MIL-F-50945D (AR)
AMENDMENT 8
12 April 2001
SUPERSEDING
AMENDMENT 7
31 August 1995

MILITARY SPECIFICATION

FUZE, PD, M567/XM935 (M935)/M936 LESS BOOSTER

FIGURE 4

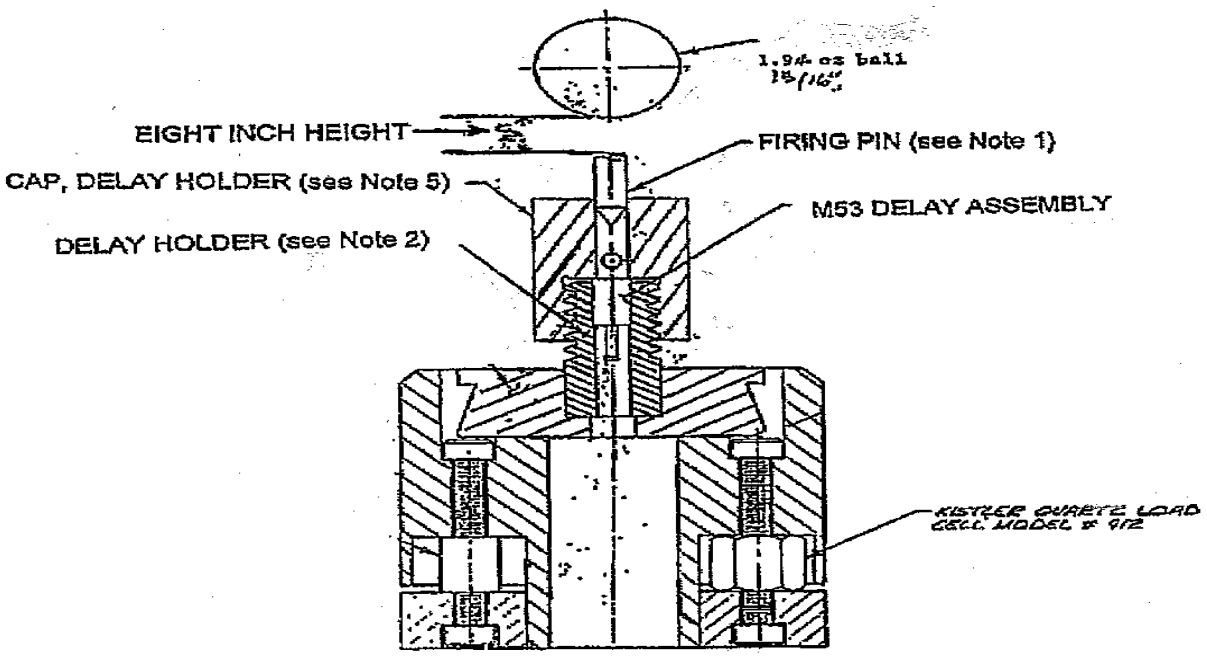
Add fig. 4 as included page 109a.

1. The firing pin tip shall have the shape defined on the M935 striker drawing 9246230. The firing pin shall be used only once.
2. The M53 Delay Assembly shall be installed in a holder before temperature conditioning. The cap for the holder shall have sufficient length to guide the firing pin over the M54 Primer.
3. The steel ball 1.96 ounce (15/16" Diameter) shall fall freely to impact the firing pin.
4. The start and stop of the delay time can either be acoustic, light detecting or shock wave. It maybe a combination of two types. The importance is the consistency of the responses to the M53 stimuli.
5. The M53 Delay Holder cap shall have four radial vents (~0.080" dia.) just above the M53 to adequately vent the F33B products.
